NOTICE OF DENIAL

RE: Application Number 23-8396; 2405 Burns St.; Indian Village Historic District

CERTIFICATE OF APPROPRIATENESS

RE: Application Number 23-8396; 2405 Burns St.; Indian Village Historic District

NORTH ELEVATION

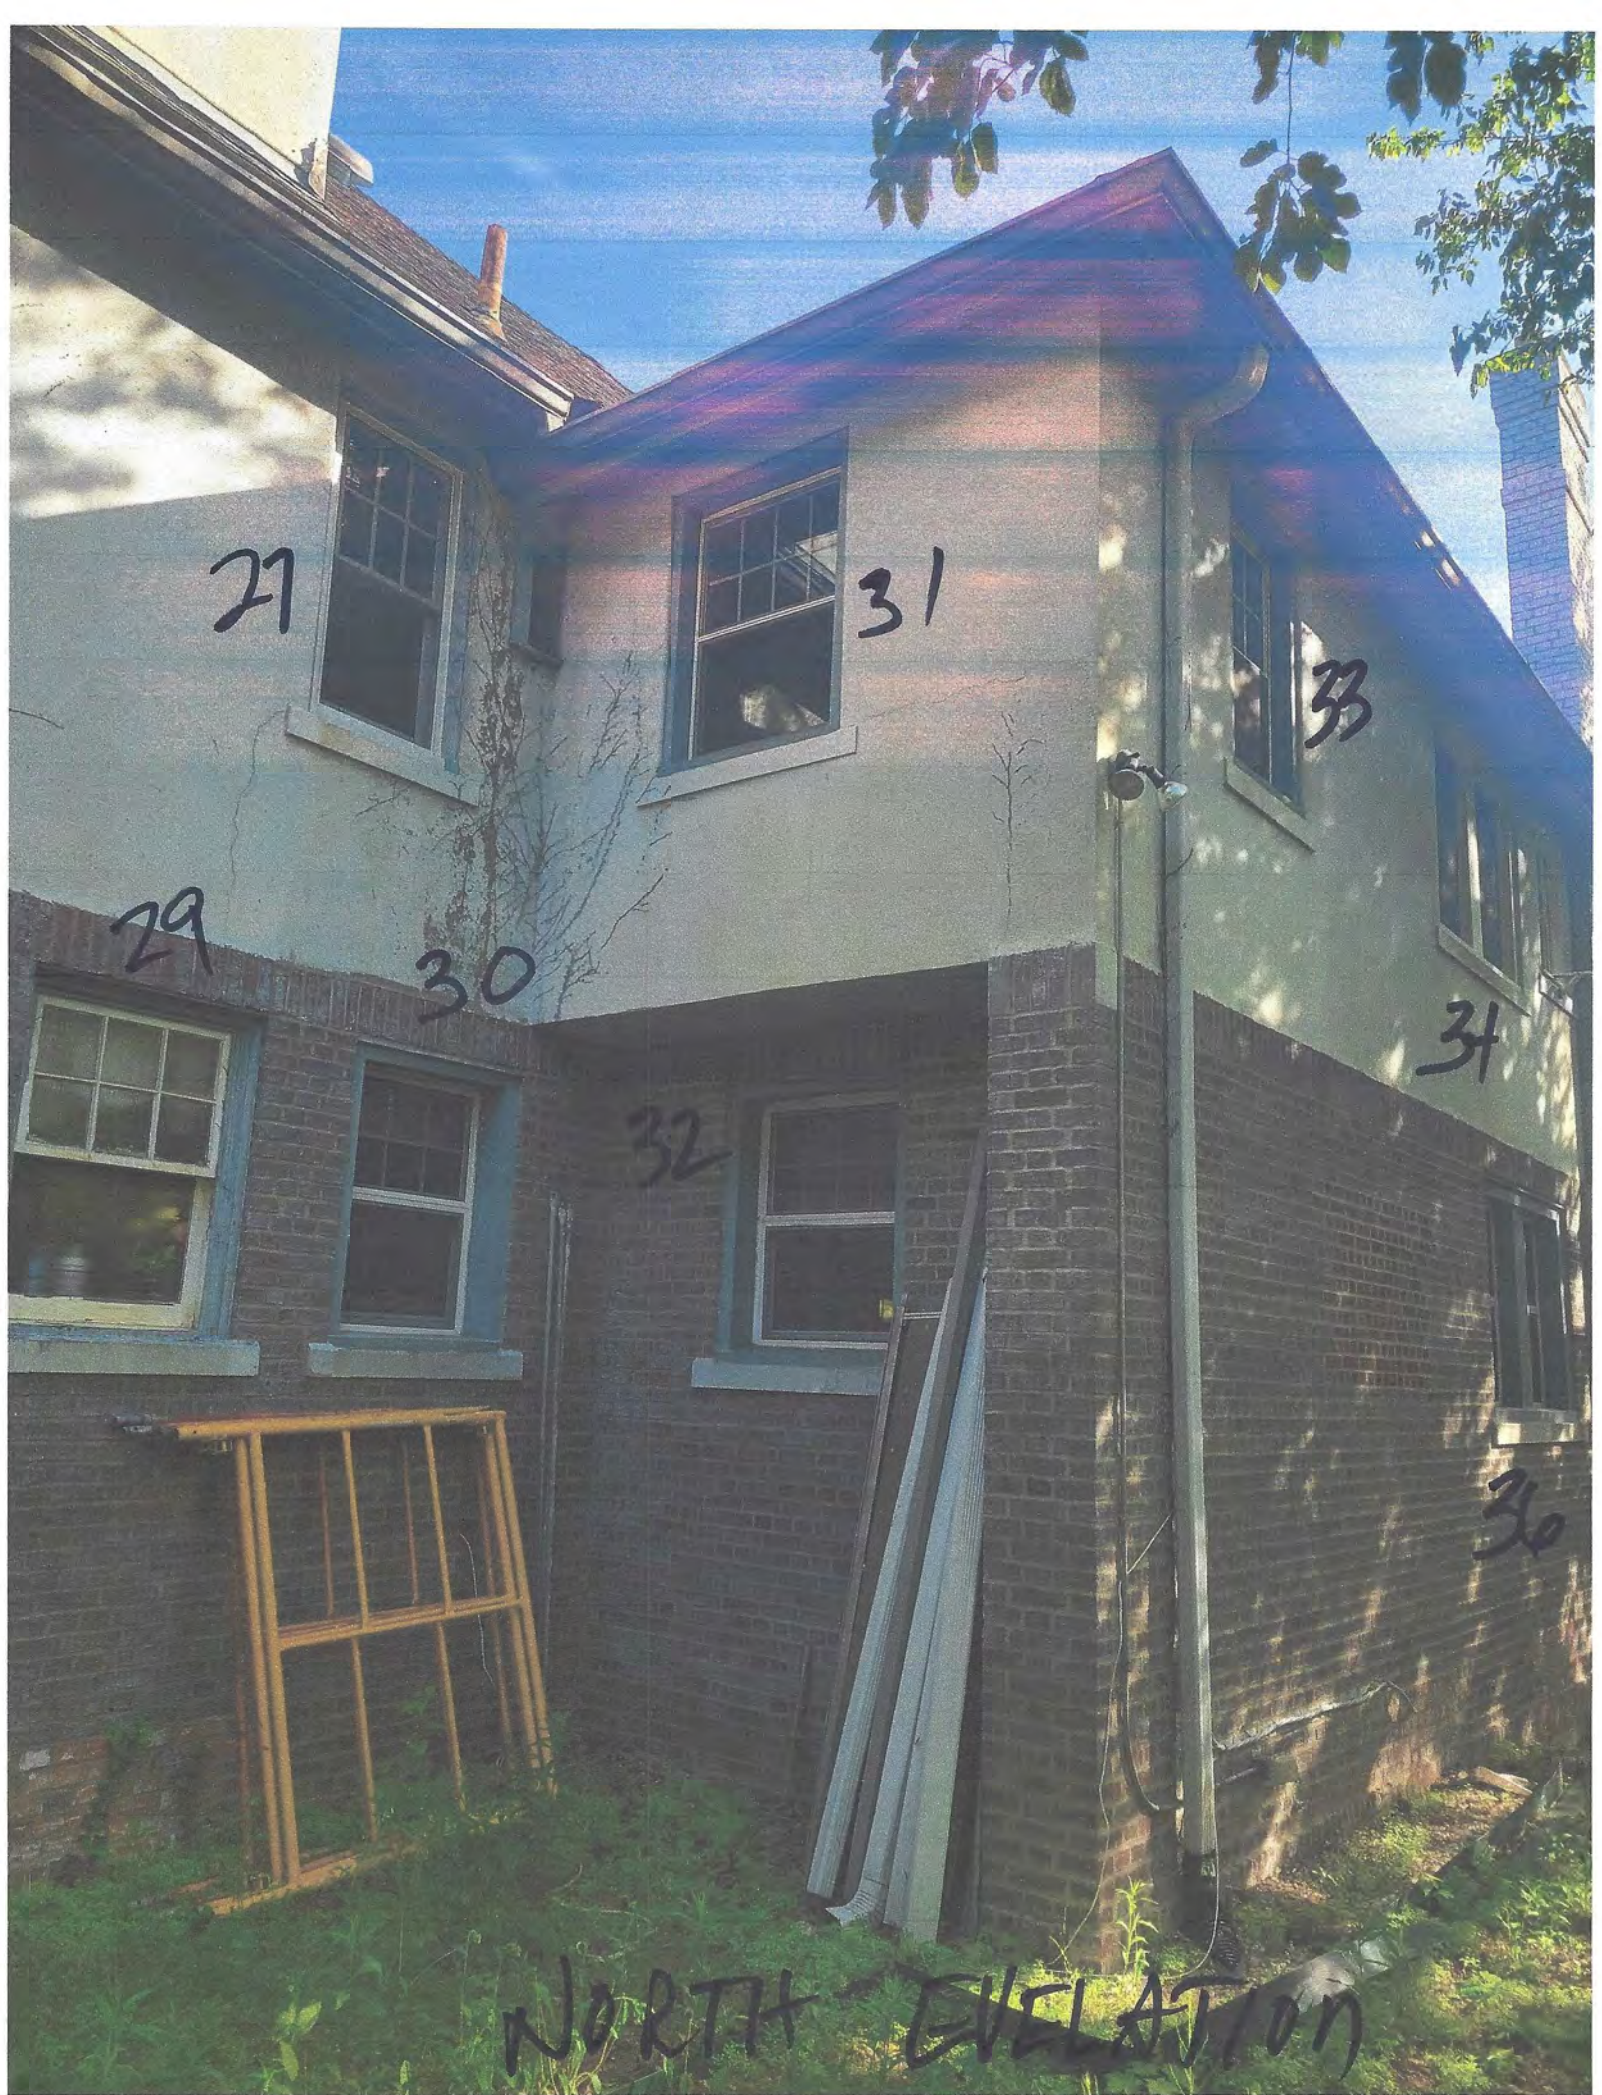
Window Renovation – North and West Elevations (6 photos):

25, 26, 29, 38, 40, 41 – Original windows still installed, will be removed and renovated.

All remaining vinyl windows on these elevations will be left as is (see note below). All break metal trim will be removed and the trim underneath will be repaired and painted.
